UNITED STATES PATENT AND TRADEMARK OFFICE

10/040,952

Office Action Summary	Application No. 10/040,952	Applicant(s) OHSHIMO, JUN	
	Examiner Mirellys Jagan	Art Unit 2859

DETAILED ACTION

Fig. 4

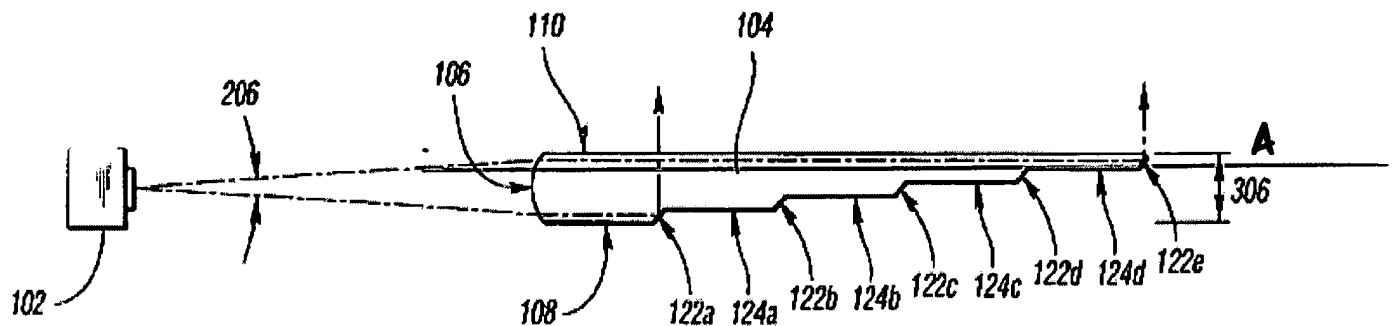
wherein the light guide takes in the light emitted from the emitter, reflects the taken-in light at a reflection portion (108) of the light guide, and ejects the light across the space toward the reflective object; the guide is plate-shaped and comprises the reflection portion disposed on one of two parallel opposing faces (110 and A, as shown below) of the guide having larger areas than the other faces thereof; the light guide takes in the light through one of the other faces (106), reflects the taken-in light at the reflection portion (108), and ejects the reflected light from the other (110) opposing face; the reflection portion comprises a series of parallel grooves (formed at the junction of facets 122 and regions 124); and the intensity of the light emitted is 'substantially' uniform over an entire area of the face from which the light is ejected (see figures 1, 3, and 4).

FIG. 5

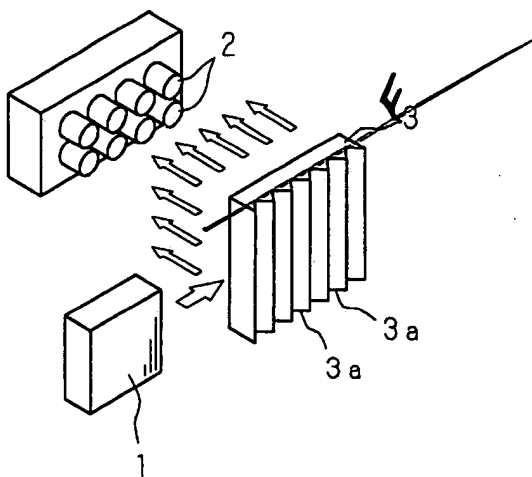
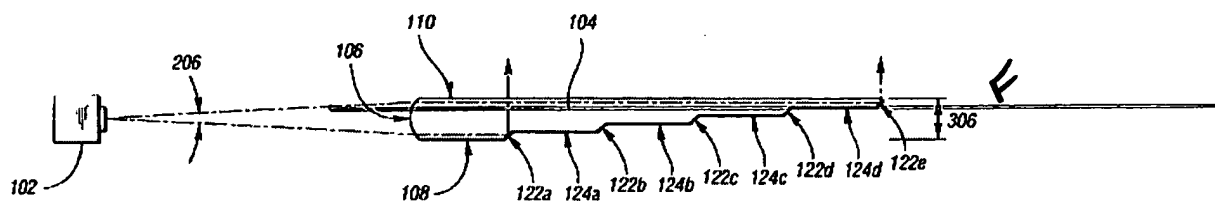
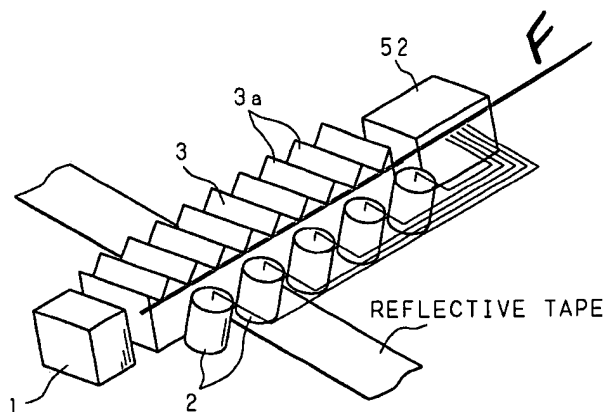
Applicant's arguments that Fohl fails to disclose a reflection portion disposed on one of two opposing faces are not persuasive. Applicant states that "top face of the light guide 3 [are] reflection portions 3a [i.e., facets] each comprising a V groove" and that "the reflection portions 3a are arranged on the *"plane"* of the light guide 3 of figure 4". However, these arguments are not persuasive since both Applicant's reflection portions and Fohl's reflection portions are on a top face/plane "F" as shown below:
